**SUBJECT: NEW VEHICLE DEMONSTRATION / DELIVERY HOLD -**

**Safety Recall 22S09 – Supplement #5**

Certain 2017 - 2022 Model Year F-250/F-350 Vehicles Equipped with a 6.2L/7.3L Gas Engine, Crew Cab/Super Cab, 160"/164" Wheelbase, 4x4, and One-Piece Aluminum Driveshaft

Loose/Sagging Underbody Insulator

FIGURE 3

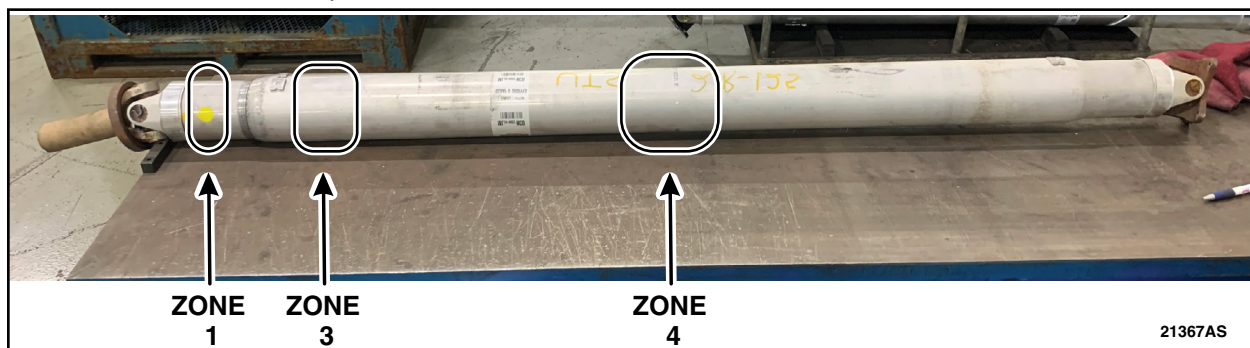
2. Inspect Zones 1, 3 and 4 of the rear driveshaft for any marks caused by the front and/or rear edges of the passenger side insulator. Are there any marks present in Zones 1, 3 or 4? See Figure 3.

Yes – Proceed to step 3.

No – Proceed to step 5.

FIGURE 4

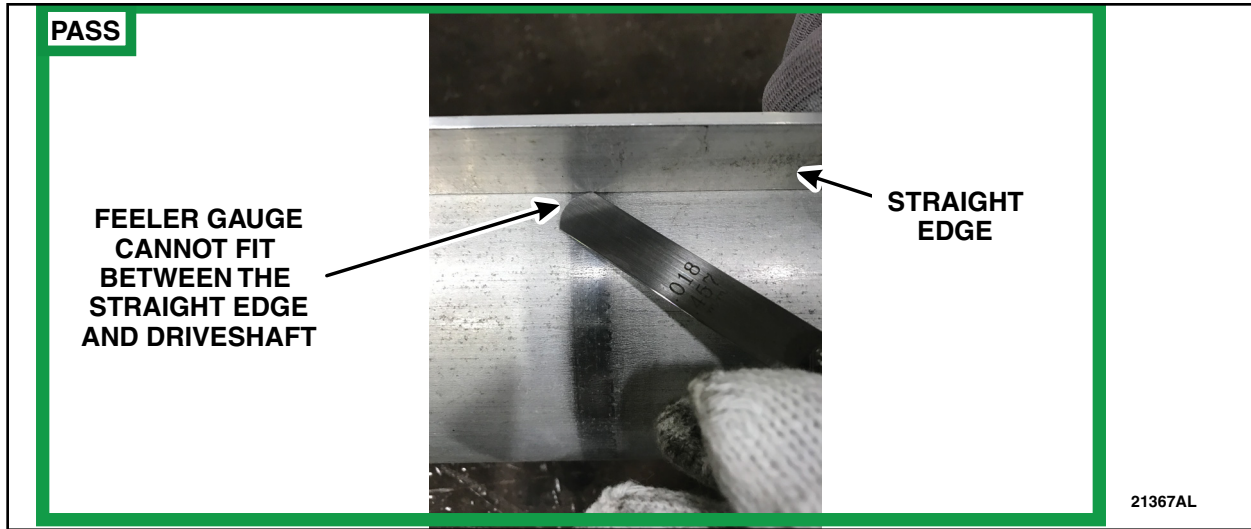
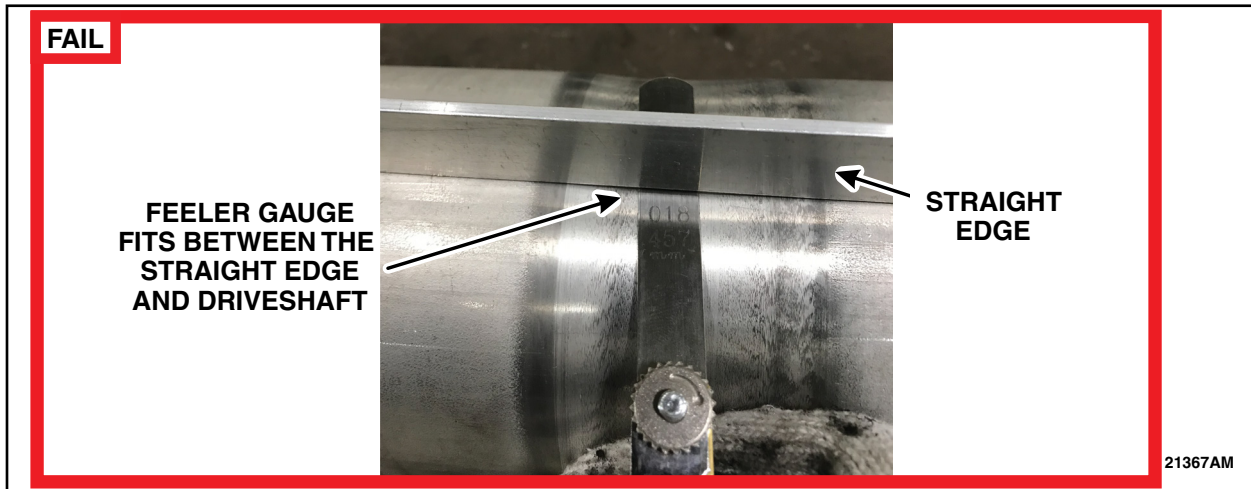
4. Place a straight edge along the driveshaft over the wear mark and attempt to fit a 0.018in (0.45mm) feeler gauge between the flat edge and the wear mark. Can the feeler gauge fit between the straight edge and anywhere along the wear mark? See Figures 4 and 5.

Yes – Does not pass inspection. Contact the SSSC and provide a picture of the driveshaft with the feeler gauge fitting between the straight edge and wear mark. Once approved, rear driveshaft replacement will be required. Proceed to step 7.

No – Passes inspection. Proceed to step 5.

FIGURE 7

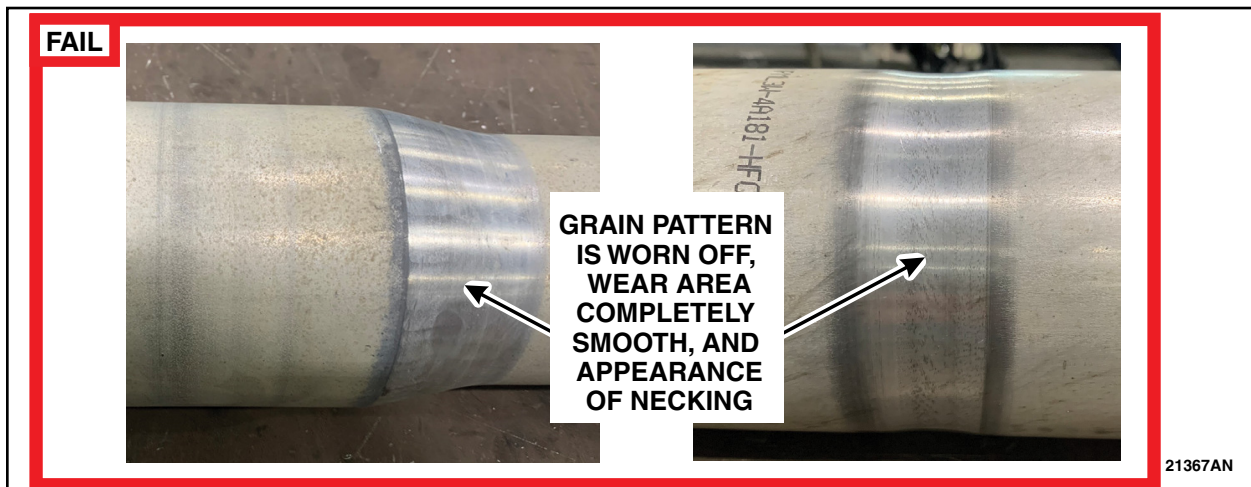
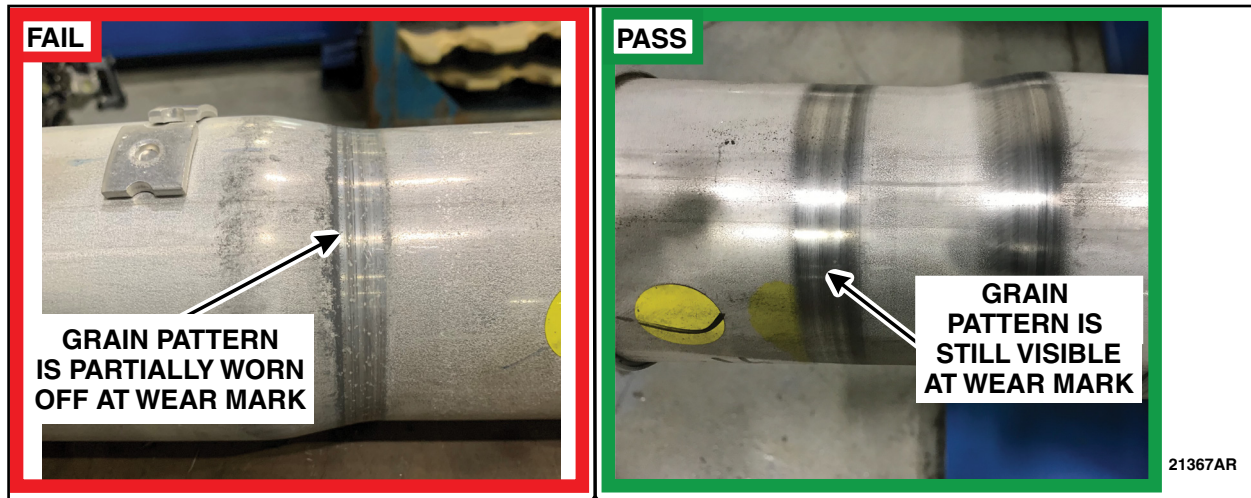
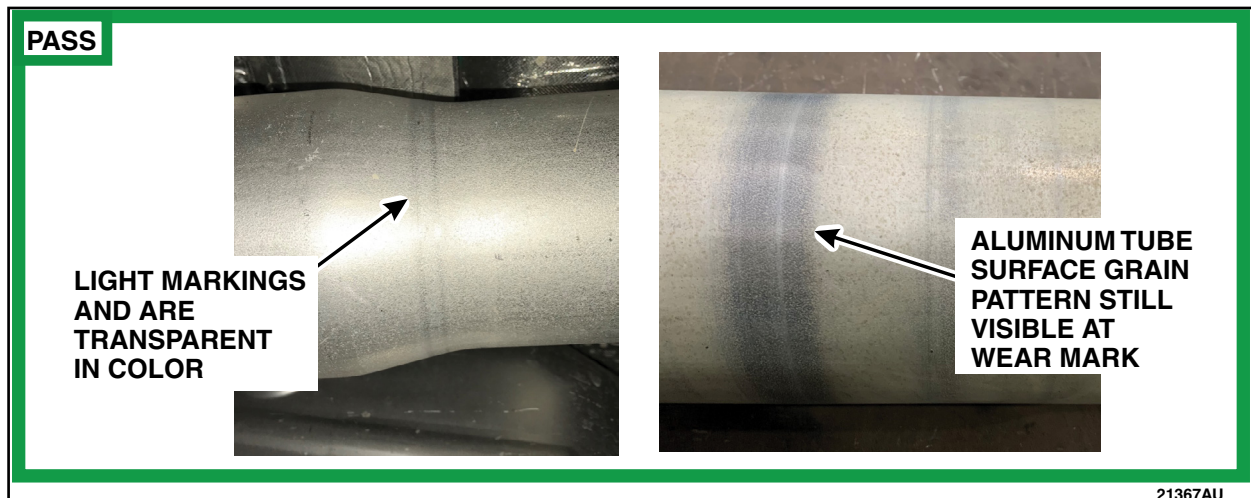
6. Inspect the marks found on Zone 2. Is the aluminum tube surface grain pattern worn off, completely smooth, or have an appearance of necking? See Figures 7 through 10.

Yes – Does not pass inspection. Contact the SSSC and provide a picture of the driveshaft with the grain pattern worn off. Be sure to show a clear image of the grain pattern missing. Once approved, rear driveshaft replacement will be required. Proceed to step 7.

No – Passes inspection. Driveshaft may be reused. **Proceed to step 11.**
